PreserveBrookline-SBNA's Response to the 40B Proposal to Expand Hancock Village

40B proposal to expand Hancock Village

Current 40B proposal to expand
Hancock Village:

Changes in the Proposal

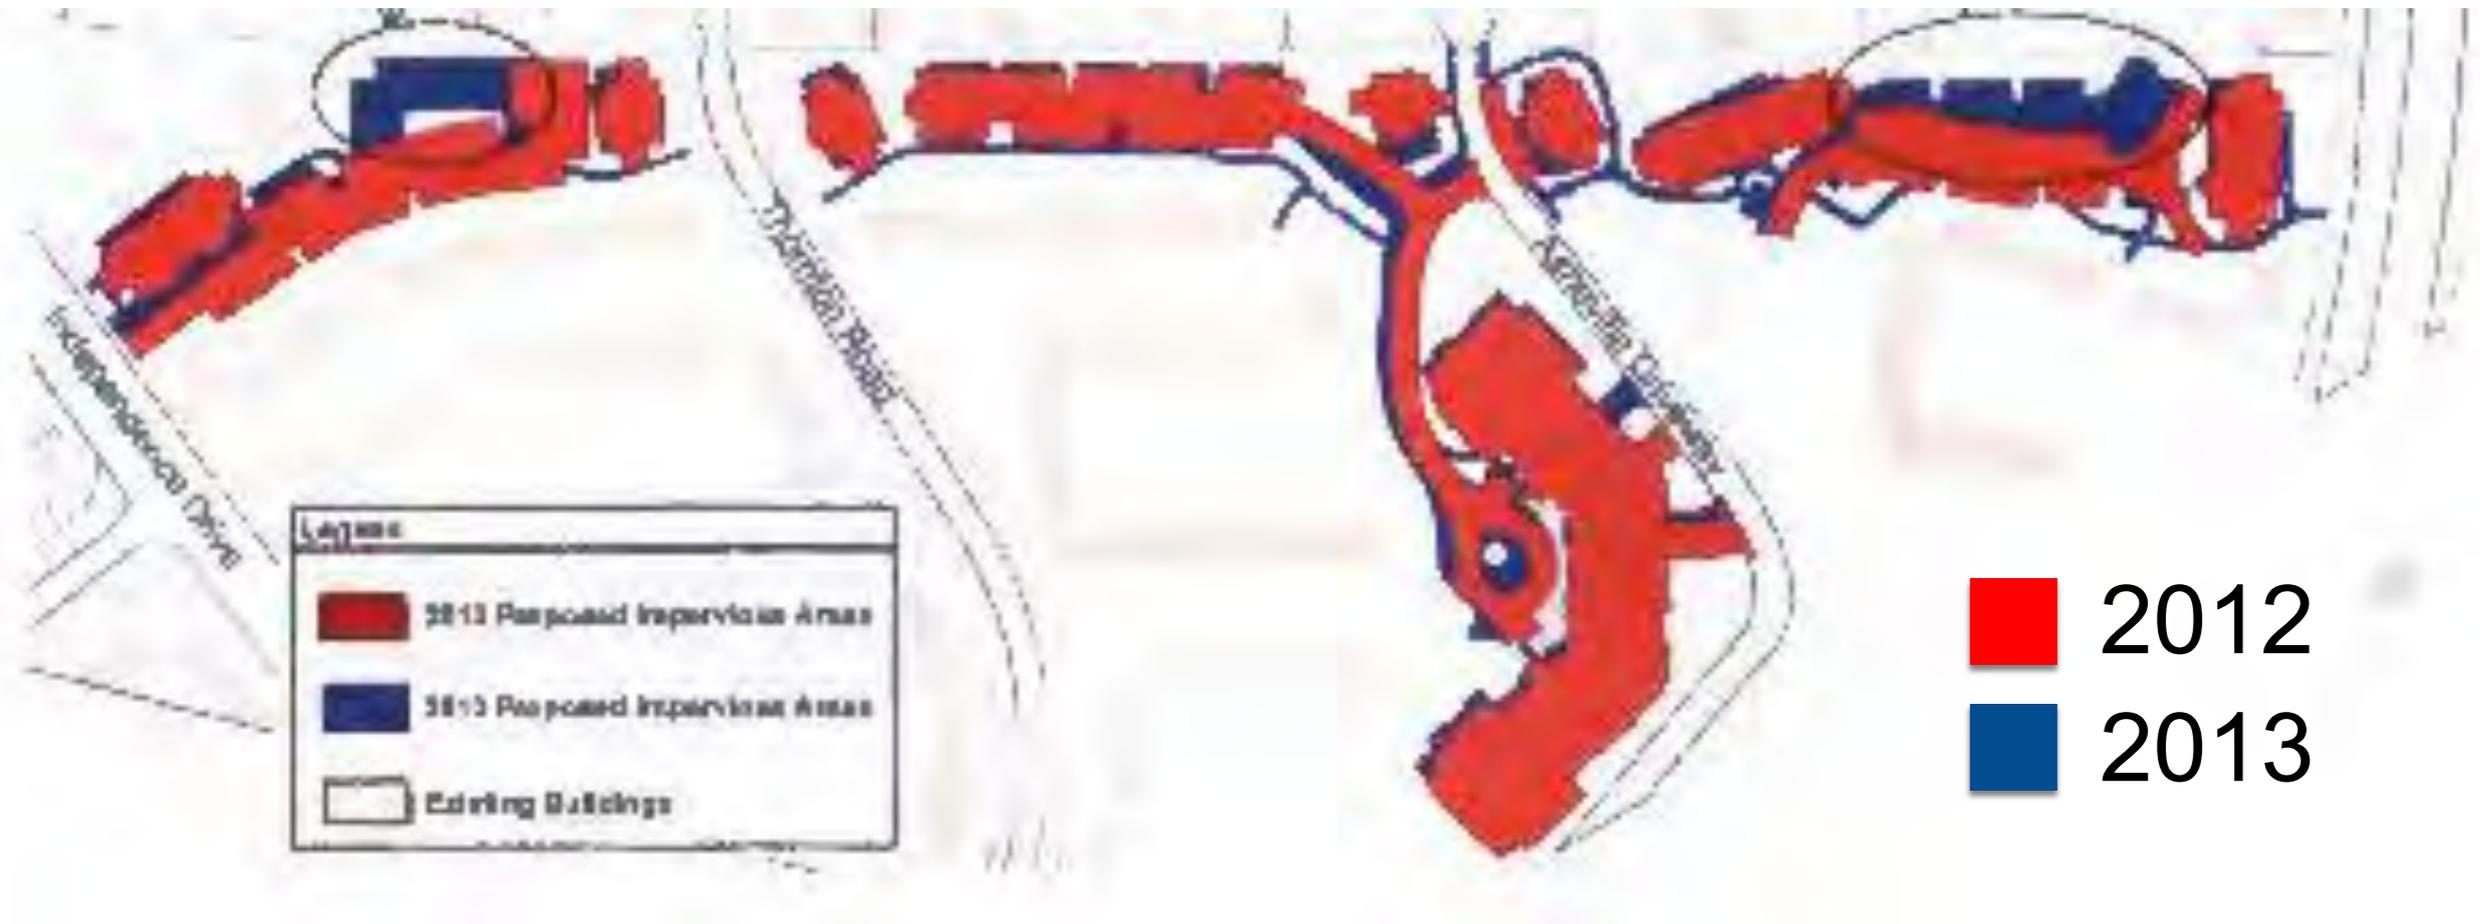
Proposal	2012	2013
Greenbelt	Road + 10 bldgs	Road + 12 bldgs
Apartment Bldg	7 stories (5 residential+ 2 parking)	6 stories (4 residential + 2 parking)

Too Big

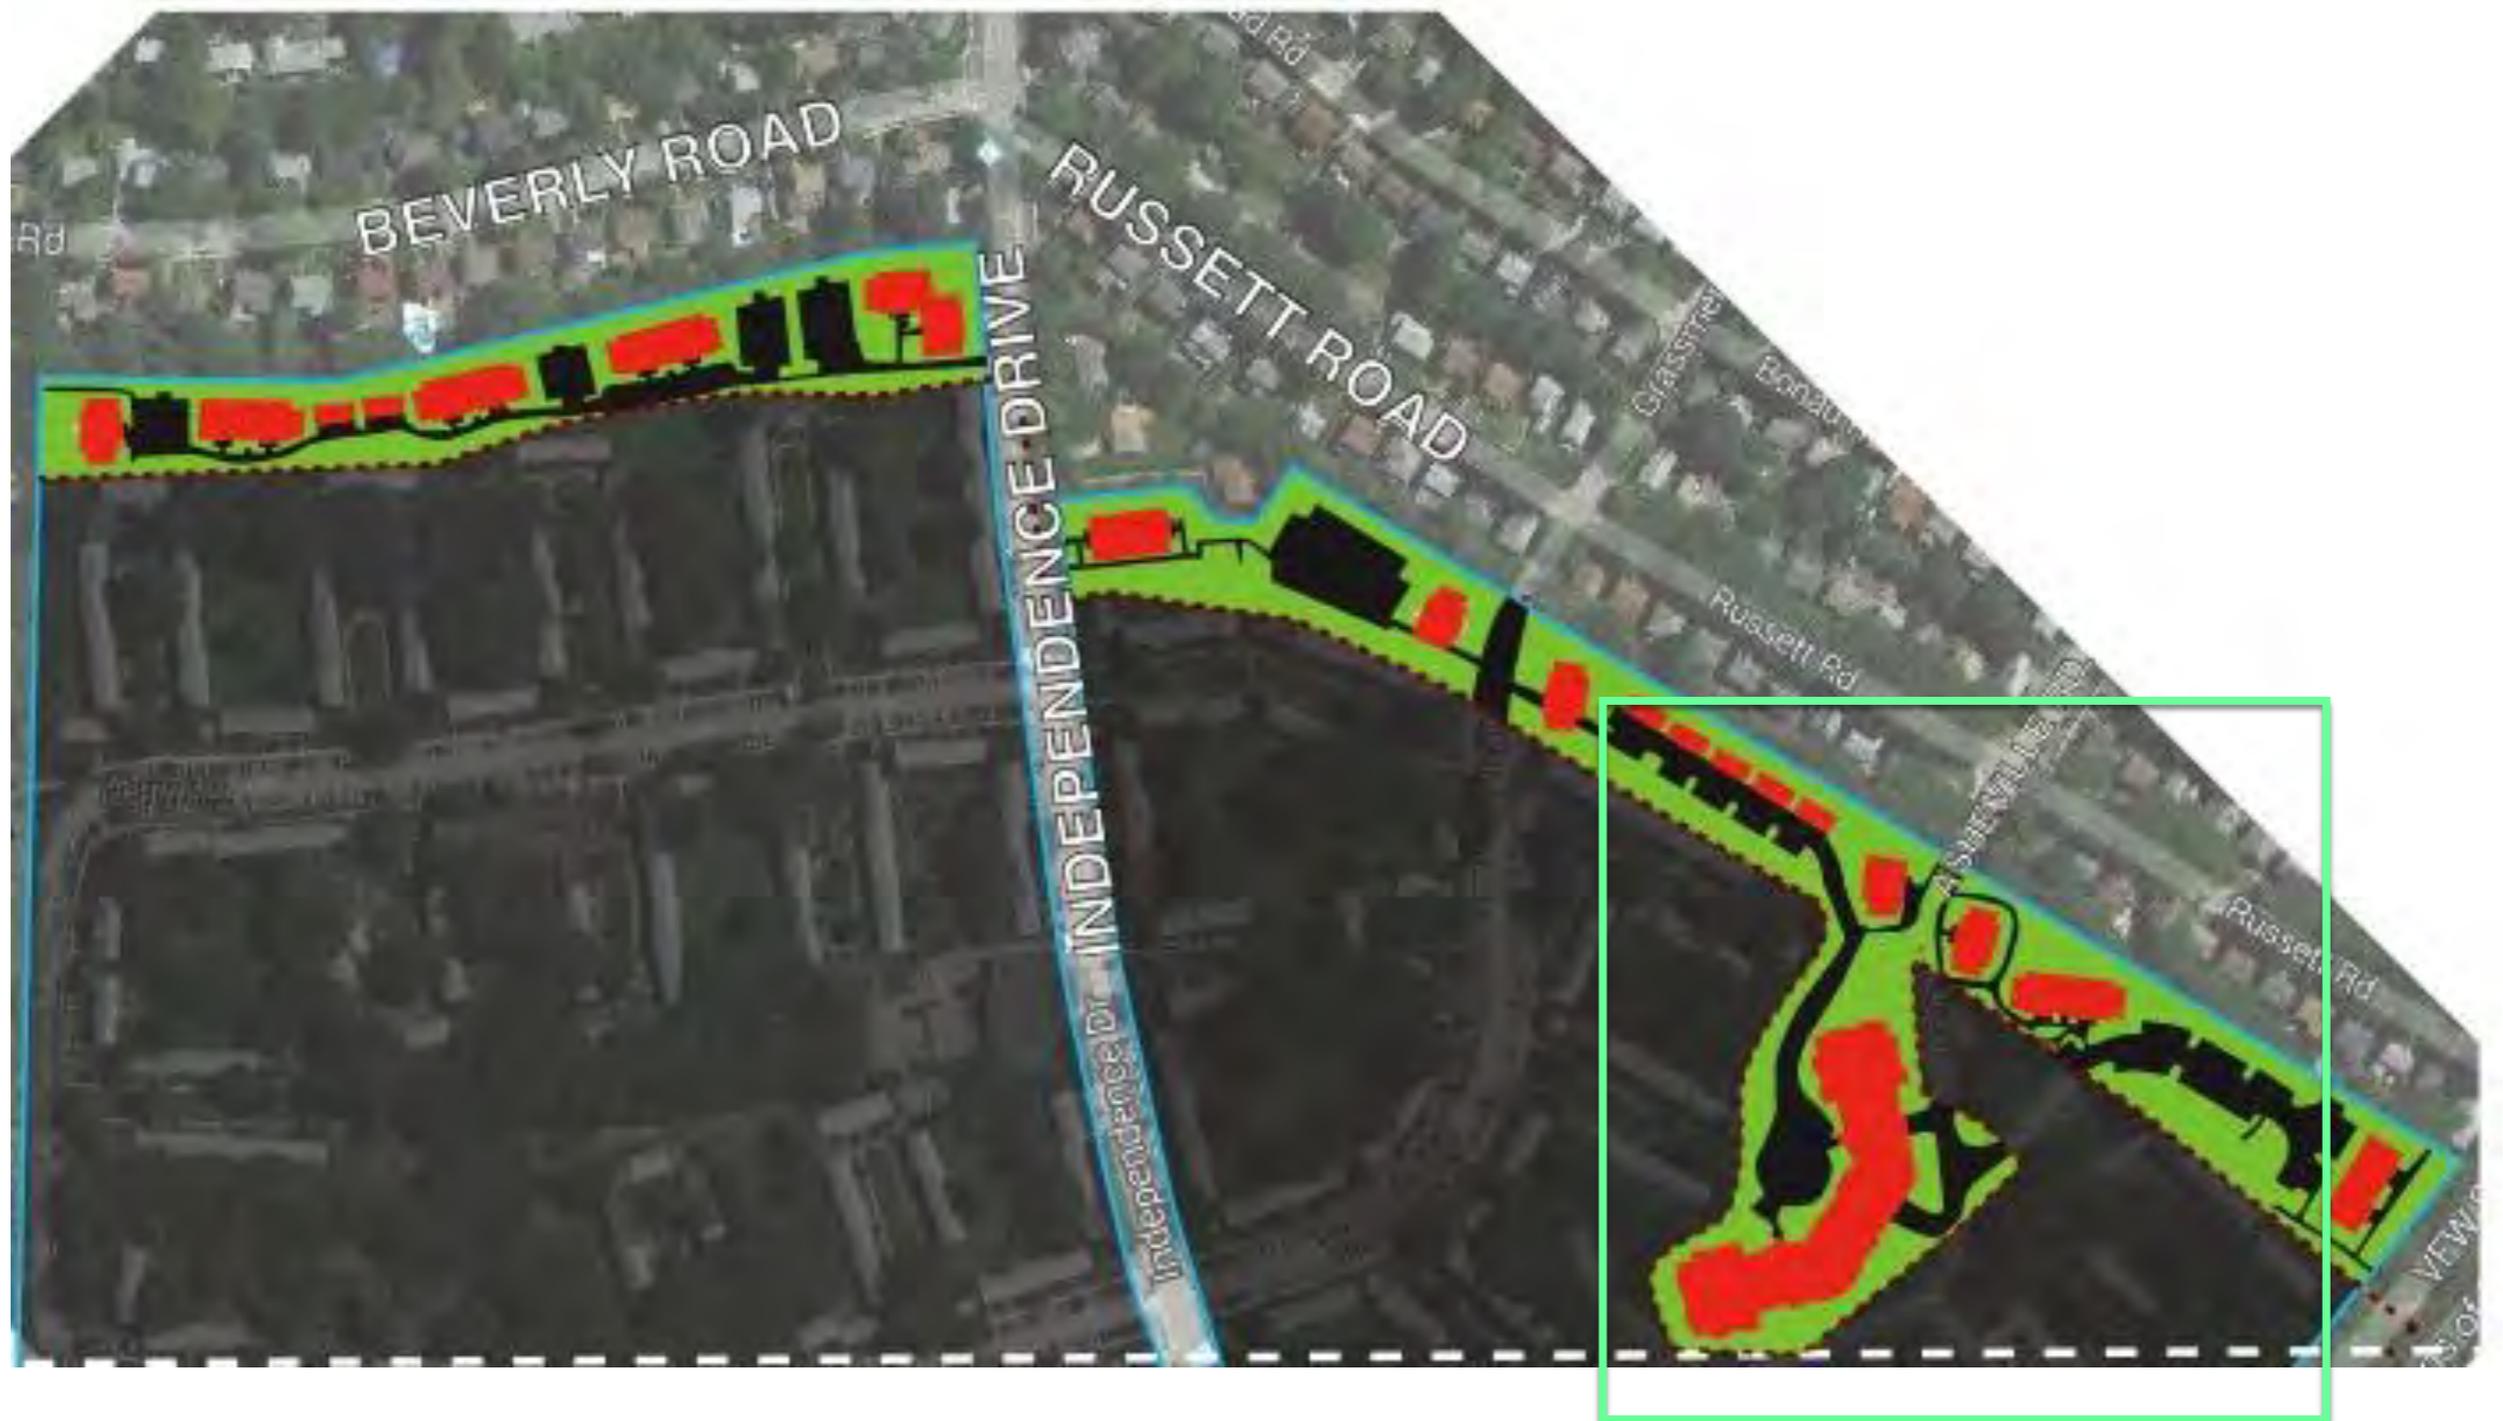
Each infill *building* is:

- Twice the width of abutting *lots*
- More than three houses wide
- ~9,500 sq ft = > 4 houses

Too Big

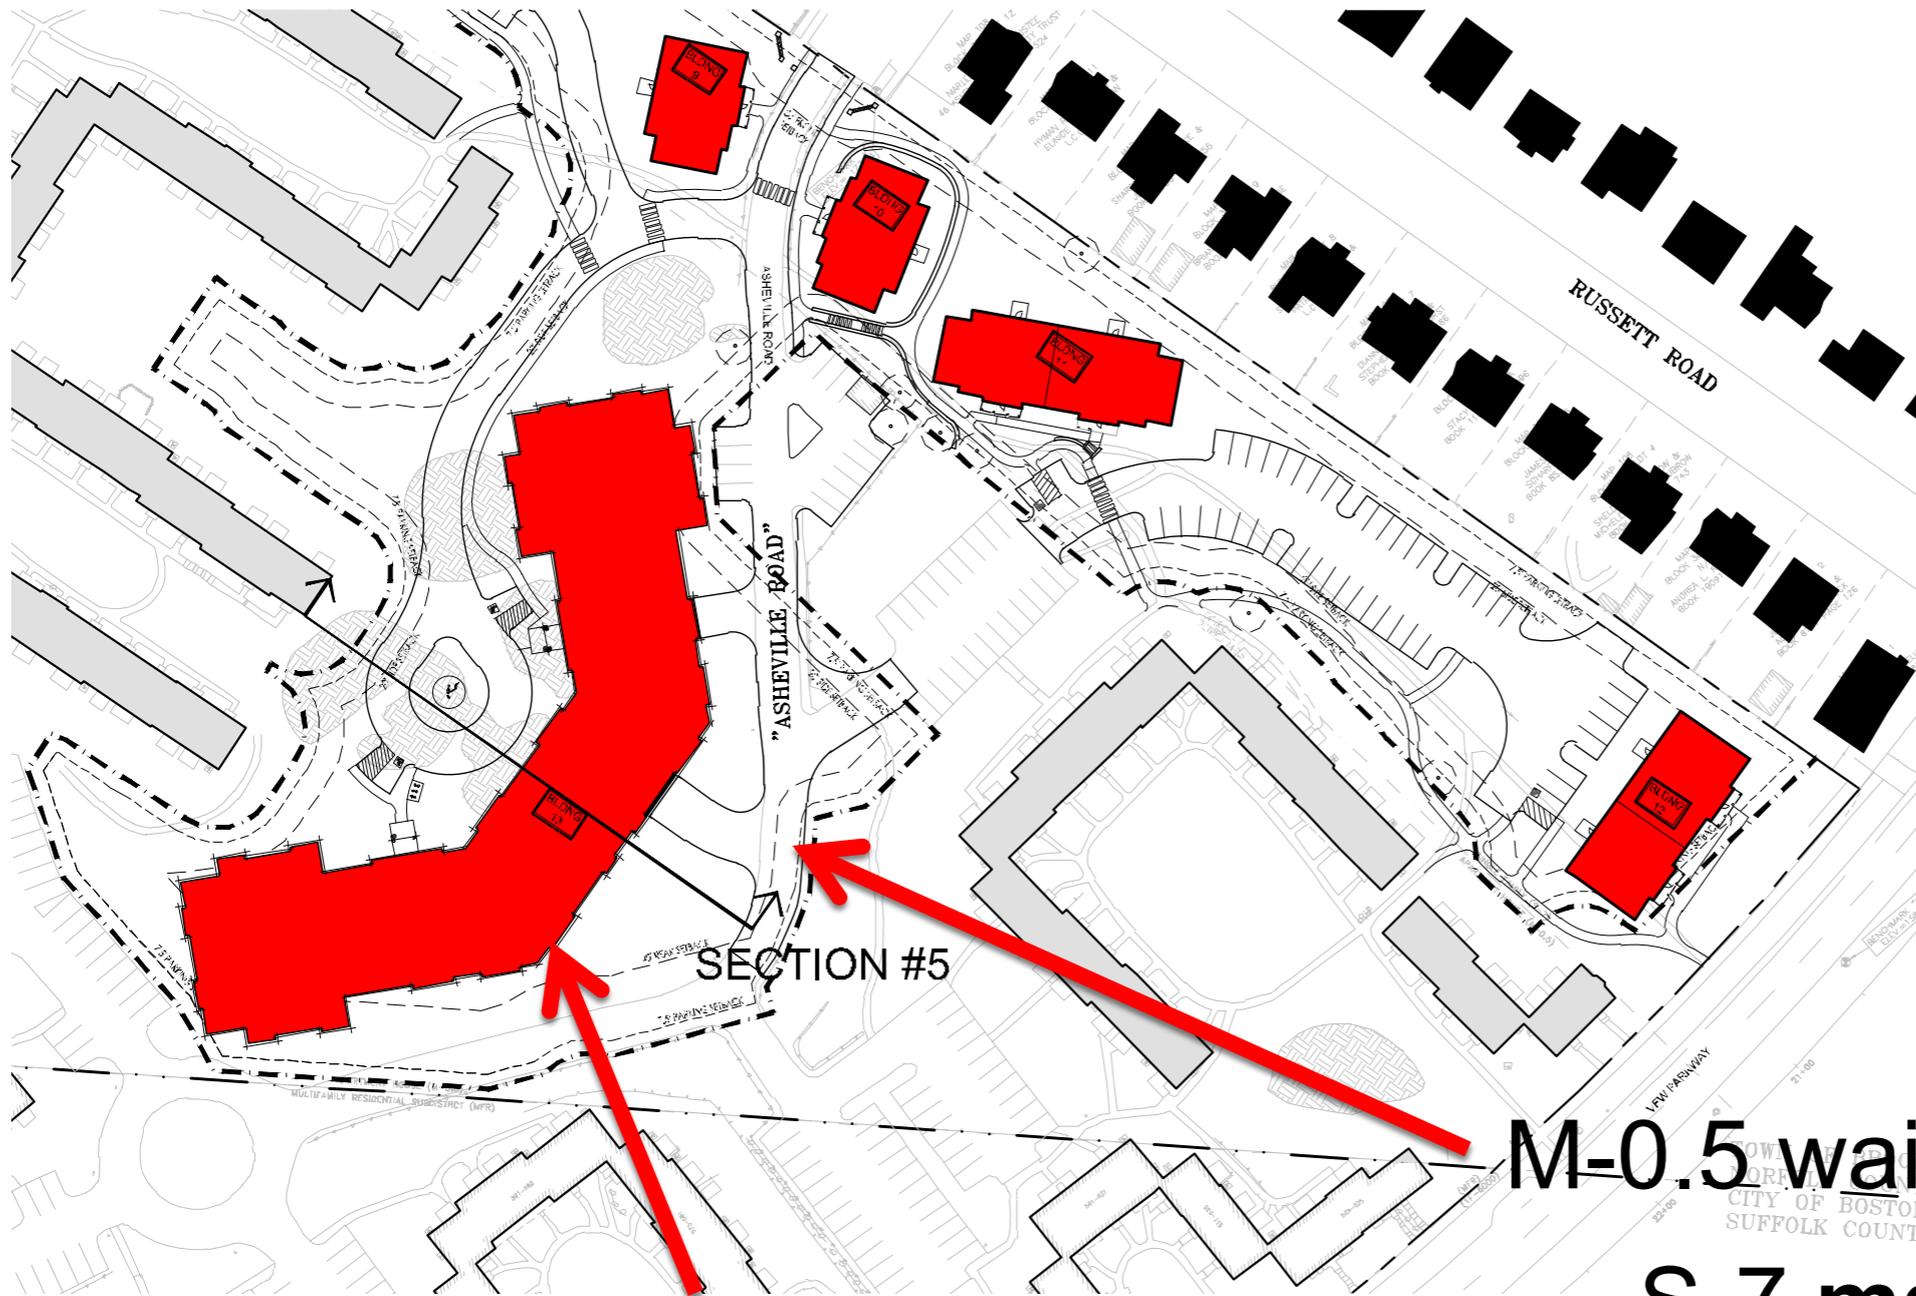
Apt bldg = ~197,000 sq ft
~98 avg homes!

M-0.5 waiver for FAR = 1.1

S-7 max FAR = 0.35
...>3x higher density

Too Big

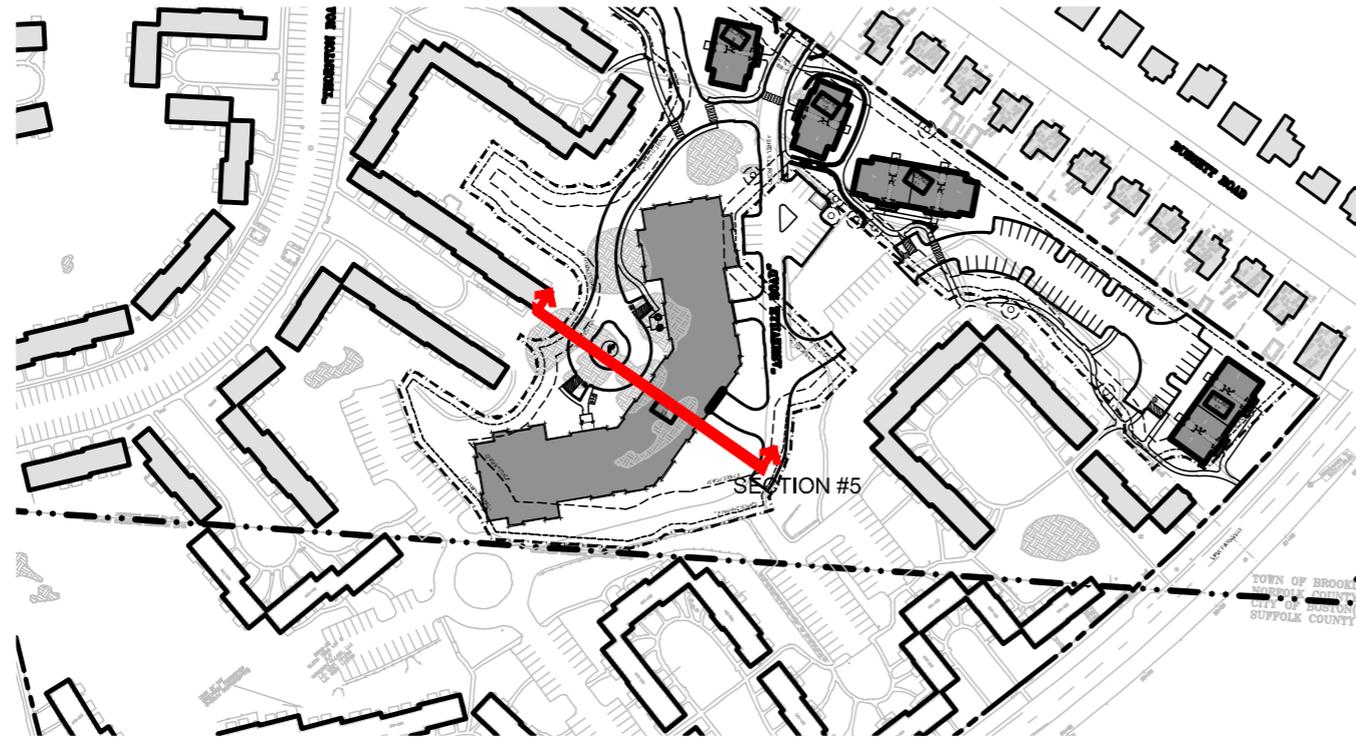
3D CHR rendering of **2011** proposal with **5-6** story apt building.

This diagram to point out the **enormous mass** of the building compared to adjoining structures.

Too Tall

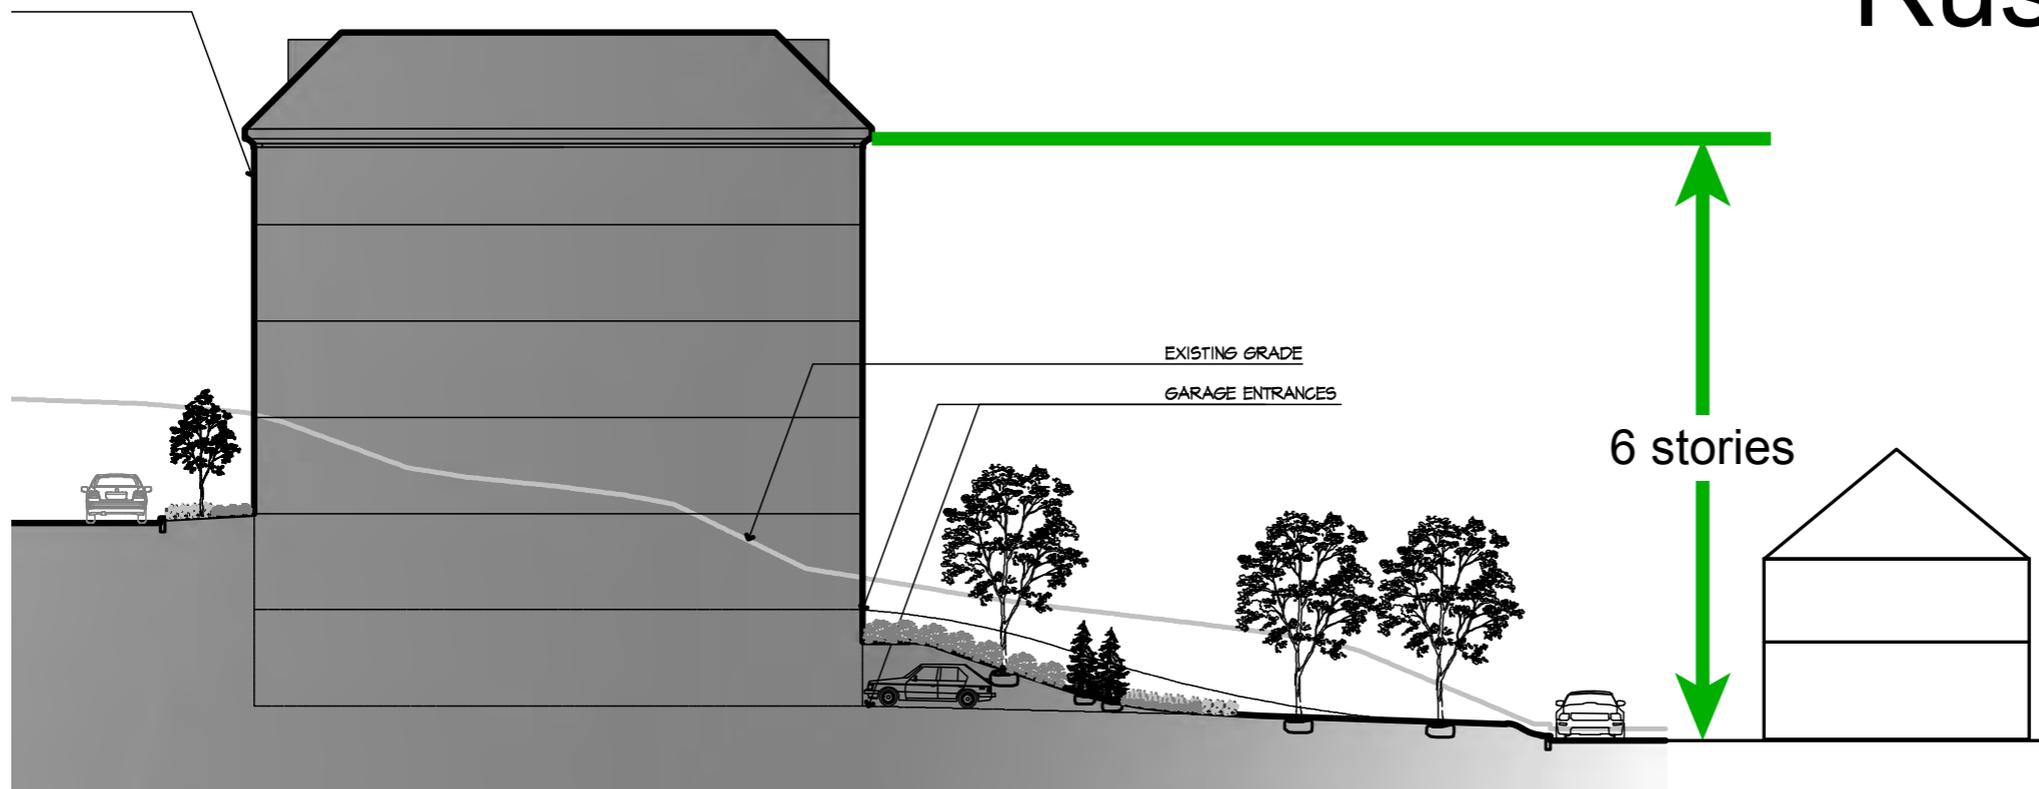
Cross-section shows that the apt building will tower 6 stories above Russett Rd.

Photo shows that the first floor of the apartment building starts at the level of the roofs of other HV and abutting properties (2 ½ stories).
The roof of the Tower will be 4 ½ stories more, ~ 7 stories from ground level
